To Draeger Customers who use:
Plus Series and PSS Series Lung Demand Valve
(All Connection Types)

August 25, 2023

**Safety Notice: Plus Series and PSS Series Lung Demand Valve – Lever Adjusting Screw
(Internal Reference PR132893 / TSB-296)**

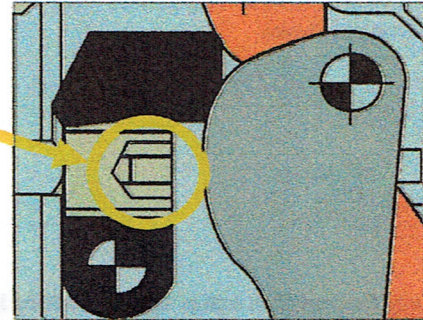
Comprehensive investigation of those devices determined that the secondary lever adjusting screw had become loose and was able to migrate and alter the primary lever height, thus affecting the LDV performance.

The service level requirement for the lever height is pre-defined and the potential screw migration can cause the lever to operate outside of the technical specifications. As the primary lever position drops, should such drop be beyond the lower service setting specification, the air flow from the LDV will gradually decrease. The worst-case failure would be a significant reduction or a full loss of the air supply.

Dräger requires all LDVs within the affected serial number range (see below) to be removed from service immediately.
